**RE: 6509 Kimmick Dr NW**  
**Grading and Drainage Plan**  
**Engineer's Stamp Date: 02/01/24**  
**Hydrology File: C09D020**

Based upon the information provided in your submittal received 02/02/2024, the Grading & Drainage Plan is **not** approved for Building Permit. The following comments need to be addressed for approval of the above referenced project:

MANUEL GARCIA FAMILY RESIDENCE  
6509 KIMMICK DRIVE N.W.  
ALBUQUERQUE, NEW MEXICO  
JANUARY, 2024

## GRADING AND DRAINAGE PLAN

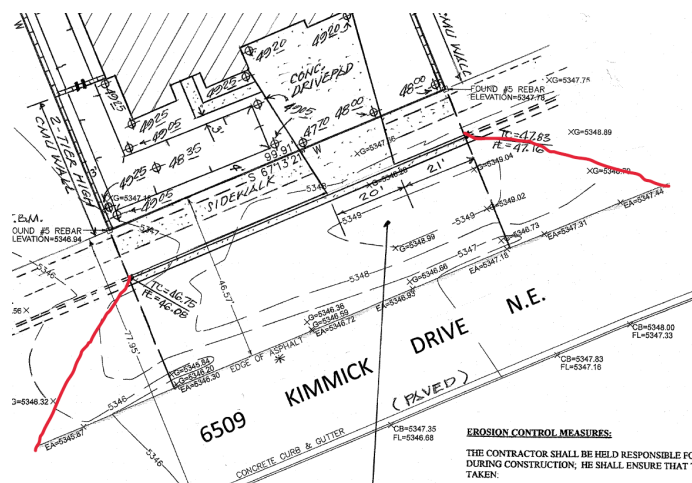
3. Please contact Zoning to determine the building height per the IDO and then verify from that the building's finished floor.
4. To be added to the Infrastructure List in Item #1, a full drainage study will have to be done on the north half of Kimmick since this was never included in SAD 228 drainage master plan. Here is the watershed that will have to be analyzed.

The watershed starts at the intersection of Rosa Parks and Utraca St. Please note that Utraca St is to have a median and the other half of the street. Please contact Transportation to determine the design of this this street and Kimmick. What I am expecting is probably an inlet somewhere at this site's location on Kimmick and then a 24-in storm drain on Kimmick to go to Unser Blvd. This will some day be connected to a future 72-in storm drain on Unser Blvd that is currently in design with a DMD project.

Please note if an inlet or 24-in storm drain needs to be built, then this also needs to be shown, added to the Infrastructure List, and the Work Order construction set.

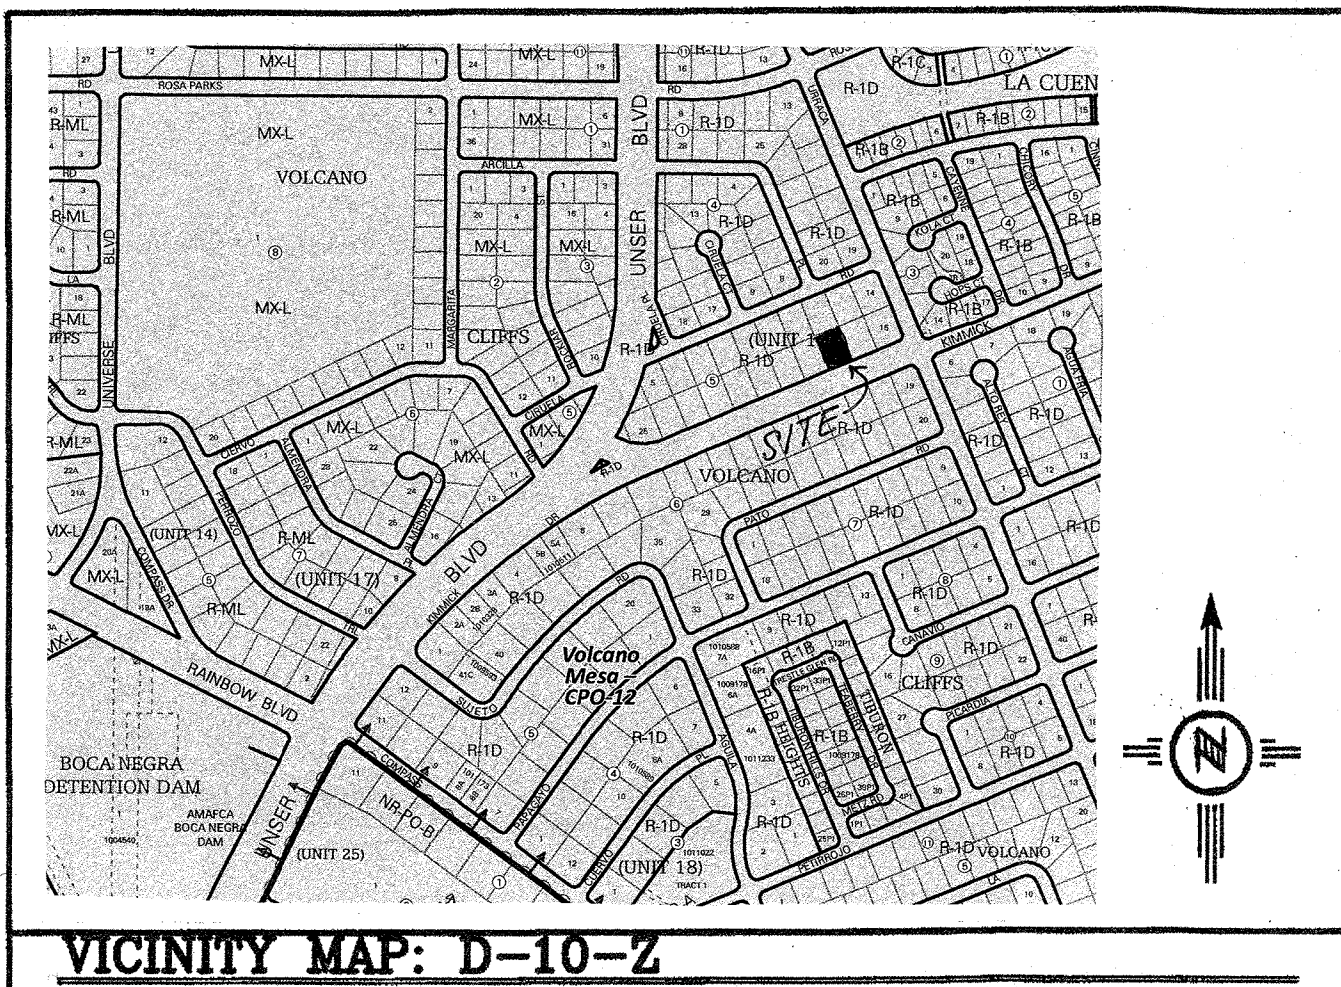
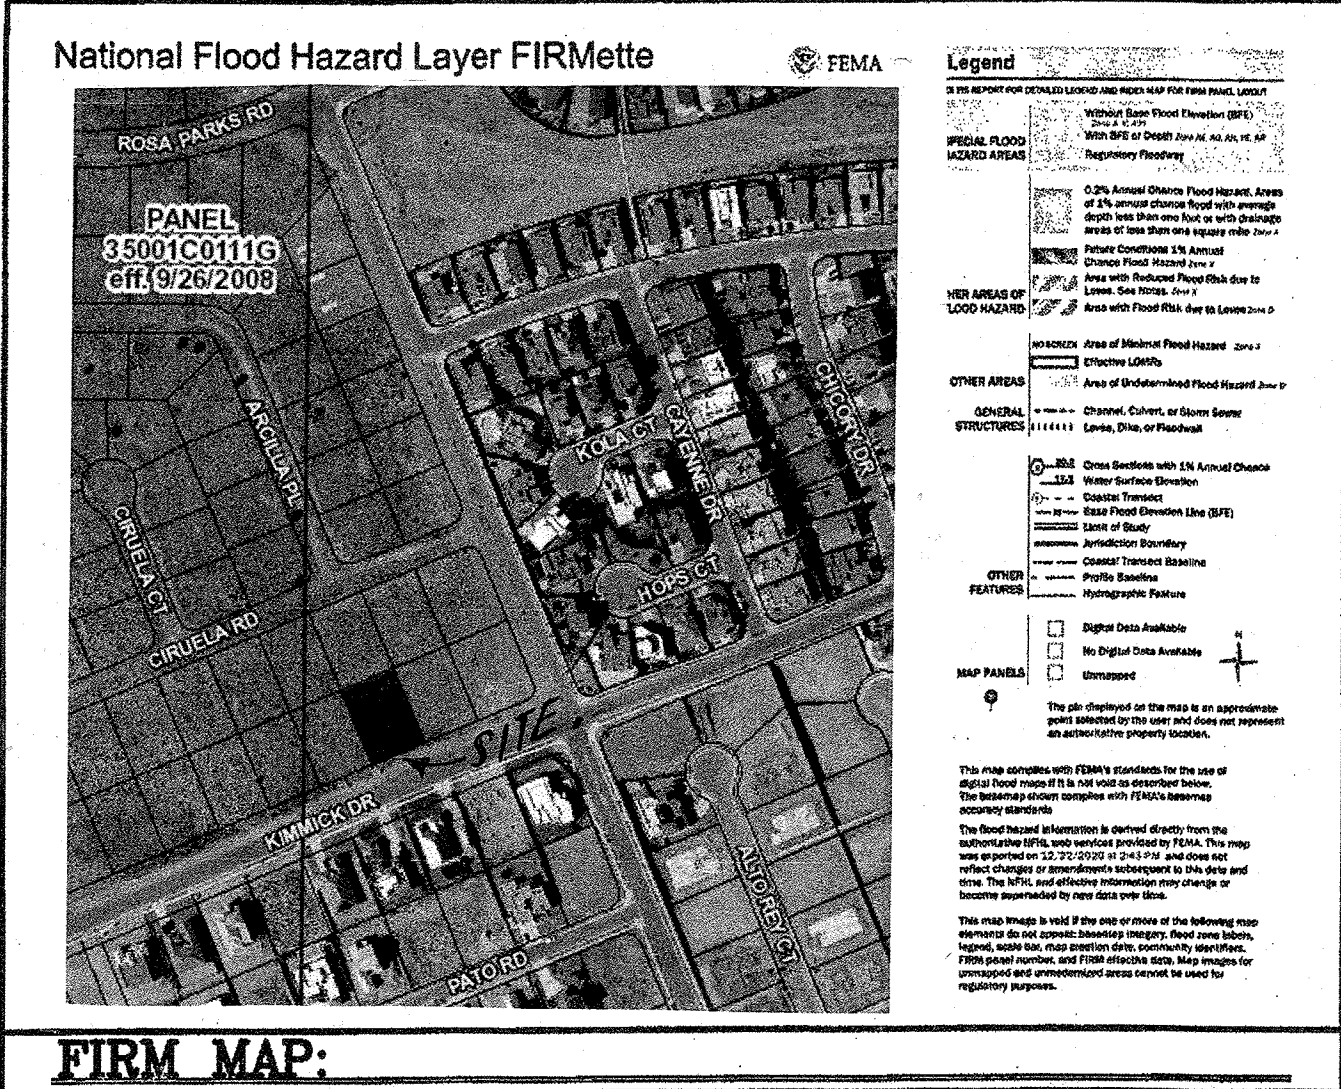
1. Per the IDO § 6-4(Q), the property owner of the property is responsible for building the adjacent half of Kimmick Dr. NW to include curb & gutter, and sidewalk. The project will have to go to the DFT for approval of the Infrastructure List. Please note that since this site also has to enter into a service agreement with ABCWUA, these connections need to be included in the Infrastructure List and the Work Order construction set that needs to go to the DRC for approval.
2. Per item #1, please show flares on both sites of the project to tie into the existing payment on Kimmick.
